Country Club Village, Preliminary Plan of Subdivision 120110260

Staff Report Date: 4/27/12

- Location: 6311 Wynkoop Blvd, Bethesda
- Zone: R-60
- Master Plan: Bethesda- Chevy Chase (1990)
- Size: 21,511 sq. ft.
- Request: Subdivide part of Parcel C into two lots
- Applicant/Contract Purchaser: Ulrike Berger
- Filing Date: June 9, 2011

Existing Slope Map for Neighborhood

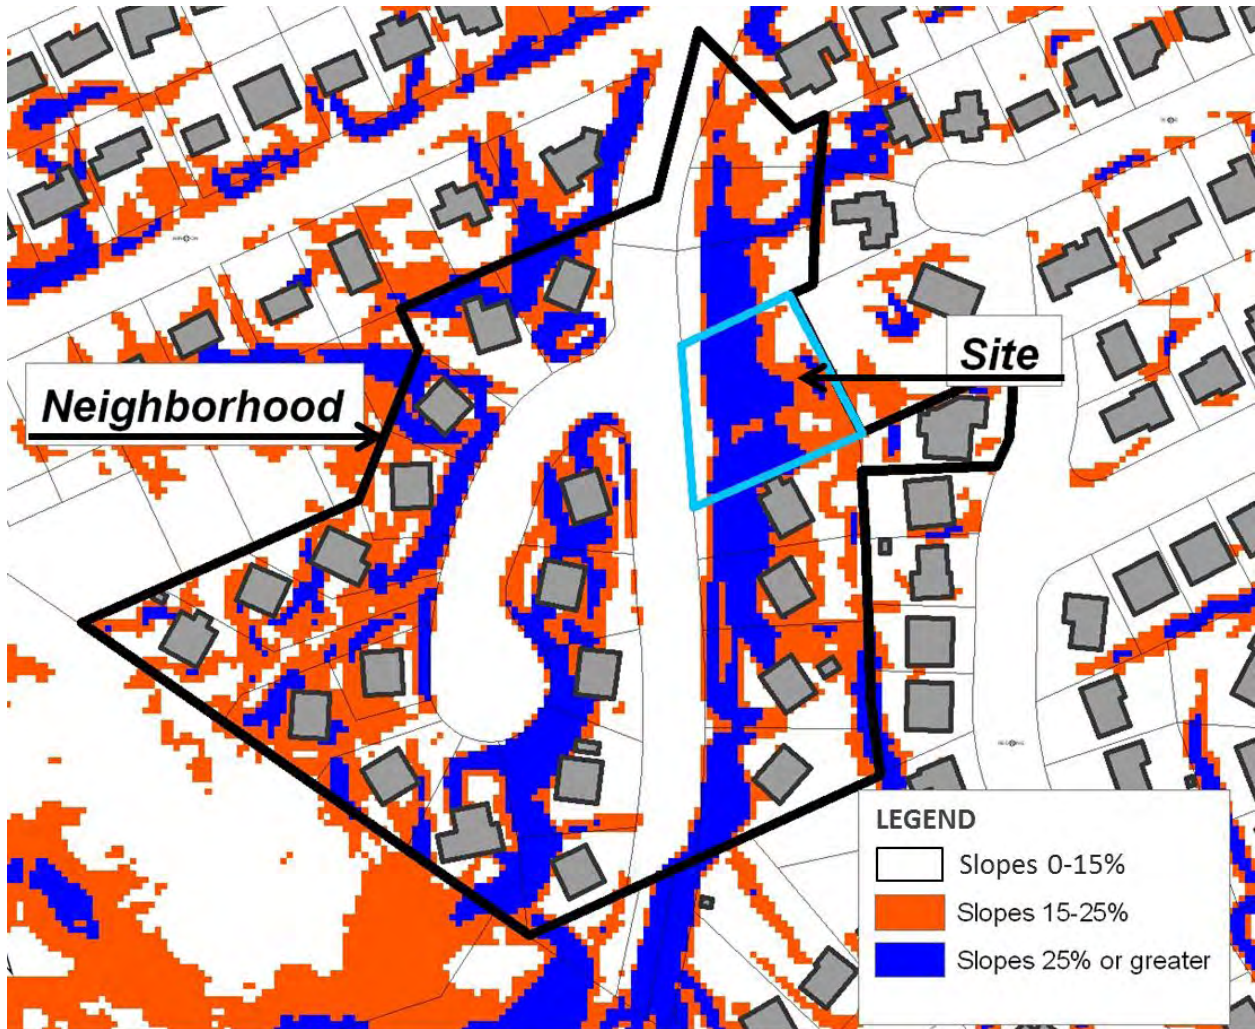
The majority of the site is Brinklow-Blocktown Channery silt loam; a highly erodible soil. The property's topography is severe. Approximately 48 percent of the site has slopes steeper than 25 percent. Another 22 percent of the site has slopes ranging from 15-25 percent, and the remaining 30 percent of site has slopes less than 15 percent.

The site has likely remained undeveloped because of the existing steep slopes on erodible soils and the potential for post-construction erosion. A topographic overlay of the development reveals that other dwellings in the surrounding neighborhood were carefully sited and tucked into the site to protect the slope and community character. (See previous figure - Existing Slope Map for Neighborhood) Lots to the south of the site were successfully developed through the careful placement of houses that averted cutting and removing steep, forested slopes and by sharing a private access easement located at the rear of these lots which provides vehicular access. The plan as submitted does not follow this careful placement as indicated by the retaining wall proposed for Lot 1.

PRELIMINARY FOREST CONSERVATION PLAN

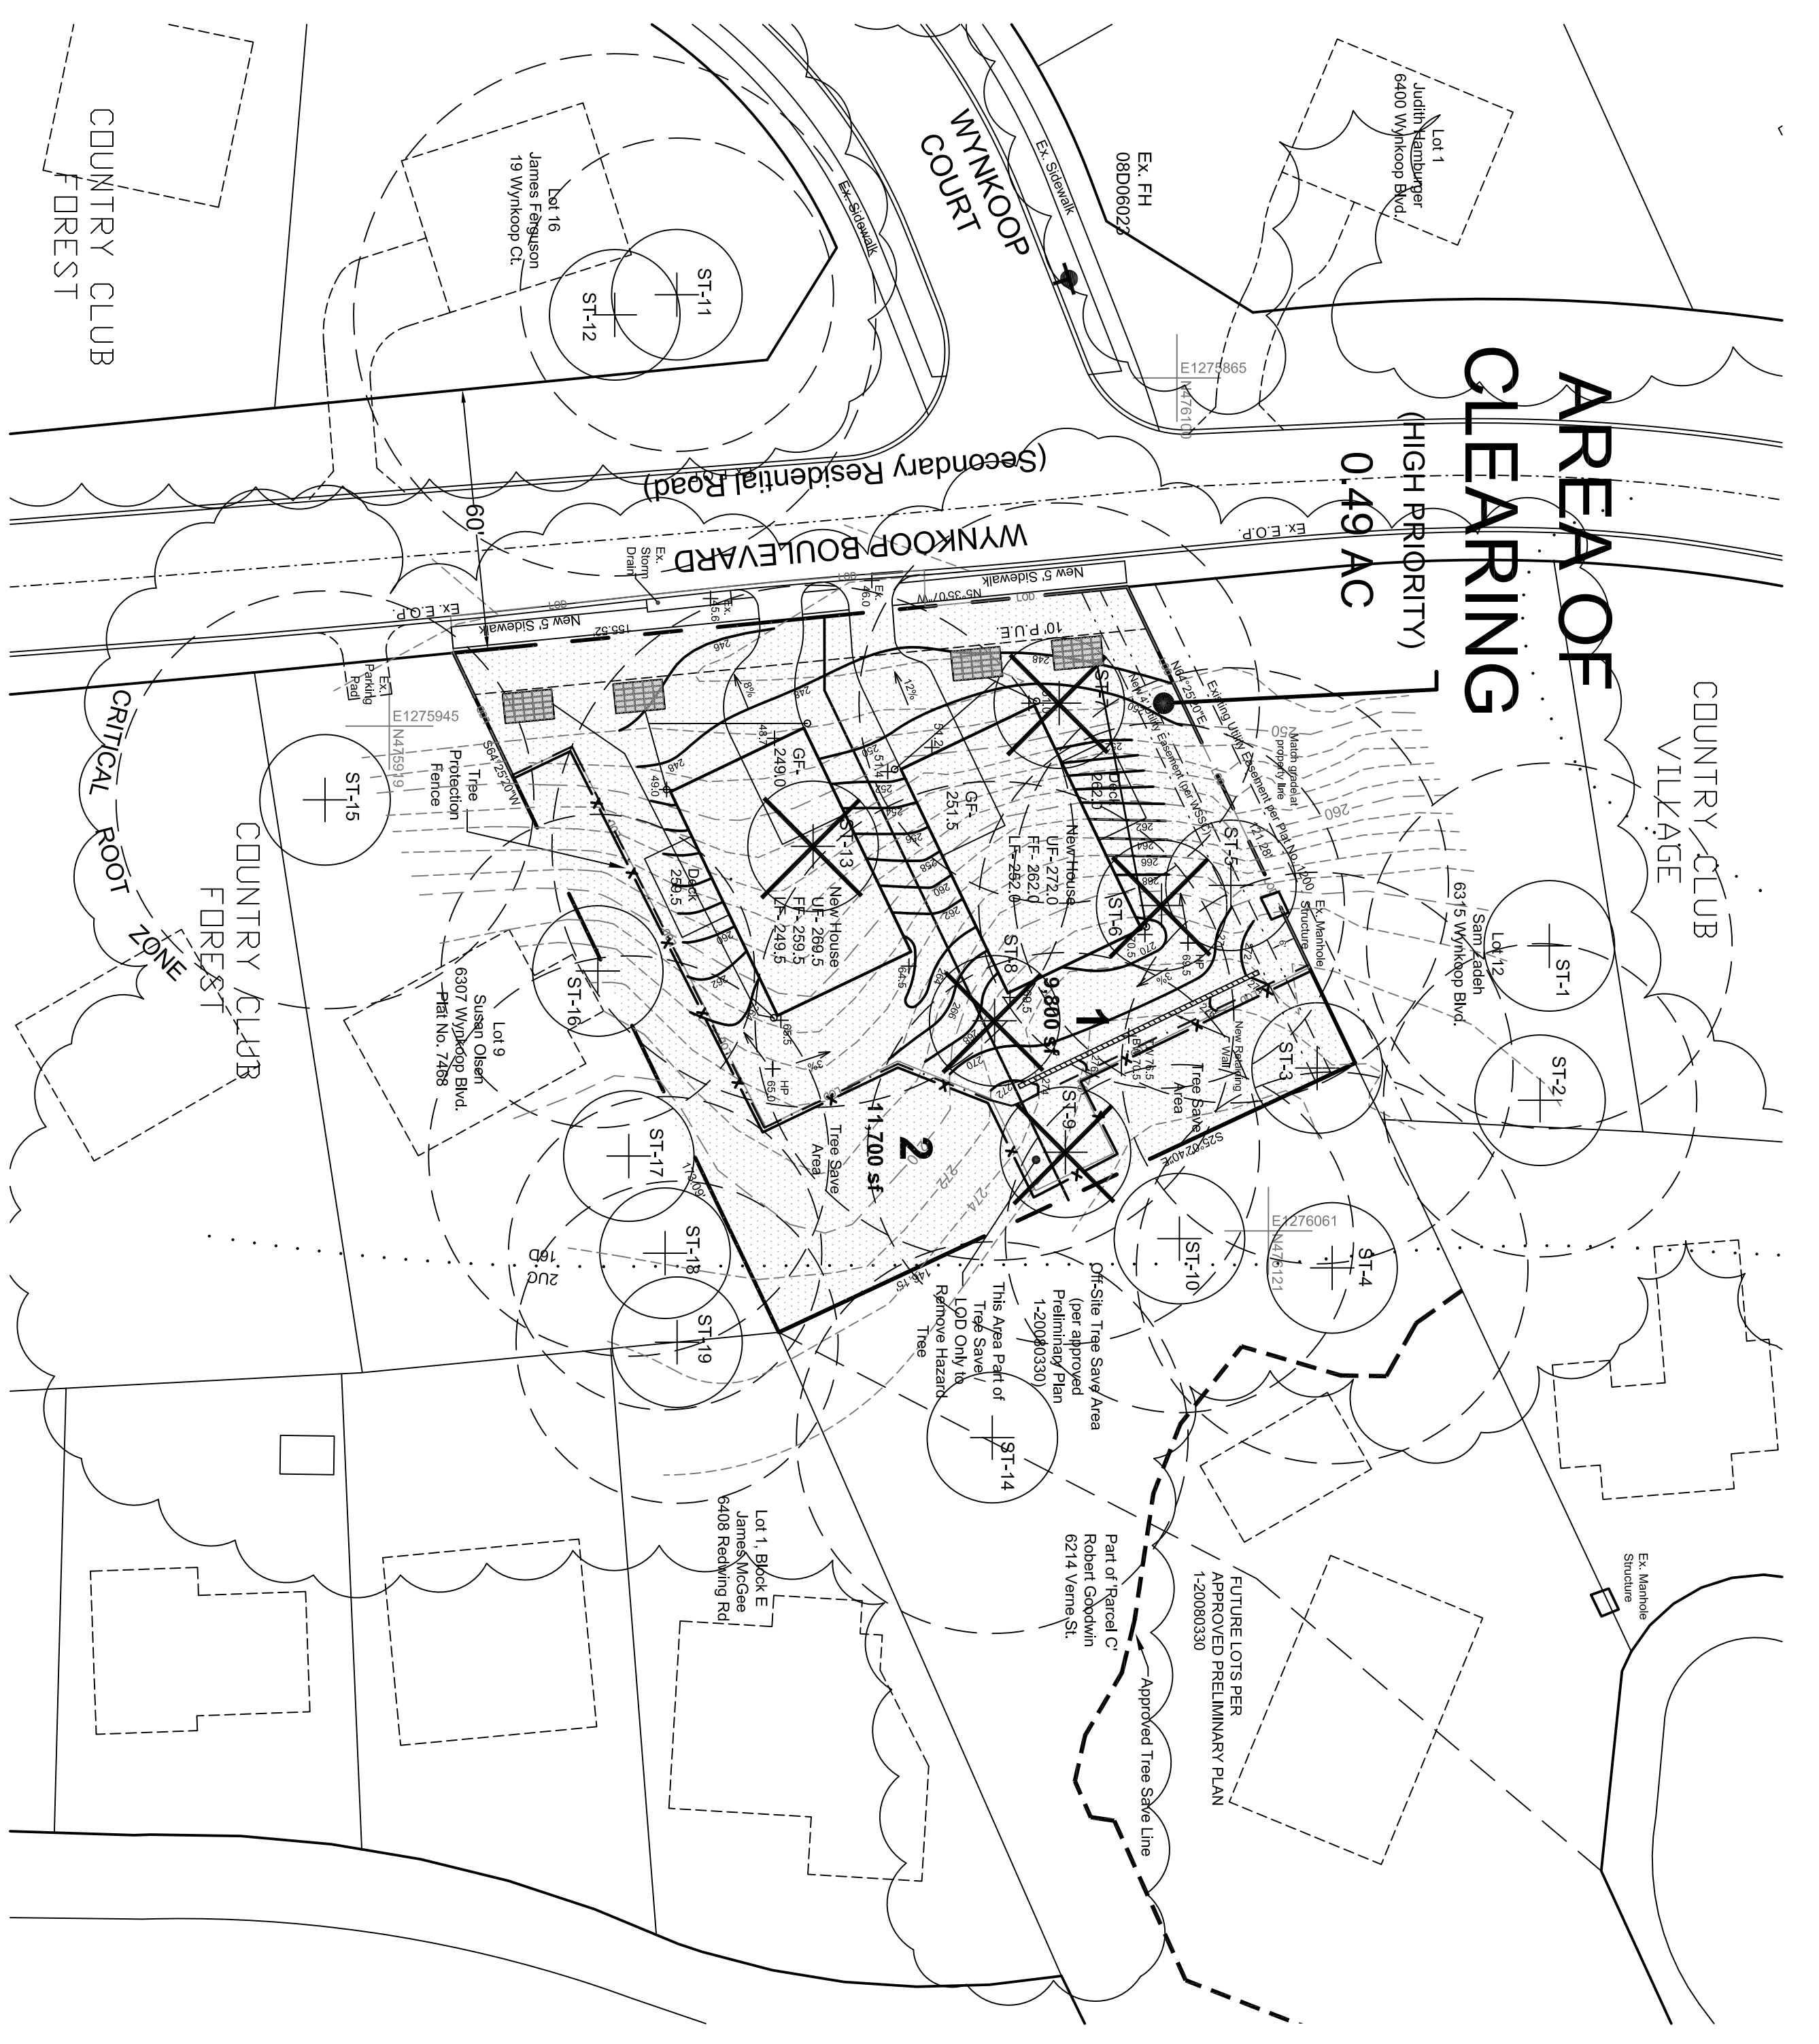
The Preliminary Forest Conservation Plan submitted on December 2nd, 2012, proposed the clearing and grading of the total tract area (0.49 acres) that includes a steeply sloped topography, a high quality forest, and erodible soils. The clearing of the lot is inconsistent with the environmental recommendations in the Forest Conservation Law, Bethesda-Chevy Chase Master Plan, Environmental Guidelines, Chapter 50-32 of the Montgomery County Code, and noteworthy historical efforts taken to protect the existing geography and ecological neighborhood character.

As required by the County Forest Conservation Law (Section 22A of the County code), a Preliminary Forest Conservation Plan (PFCP) for the project was submitted with the preliminary subdivision plan. The PFCP proposes to retain 0.0 acres of the total 0.49 acres forest tract. The applicant proposes to meet all reforestation/afforestation requirements (0.29 acres) offsite or through a fee-in-lieu payment.

Section 22A. 00.010.03 Transition Provision. B. Terms Defined. (2)(b)(20) "Forest Conservation Plan means a plan which outlines the strategies and specific plans proposed for *retaining, protecting, and reforesting or afforesting areas on a site.*" The applicant has not demonstrated an effort to retain, protect, and reforest/afforest trees onsite.

The Plan as submitted does utilize any planning or zoning methods for forest or tree protection.

The Plan has made no effort to protect either the forest or vegetation.

The Preliminary Forest Conservation Plan has not met all the applicable requirements. Therefore, staff recommends denial of the Preliminary Forest Conservation Plan and Tree Variance.
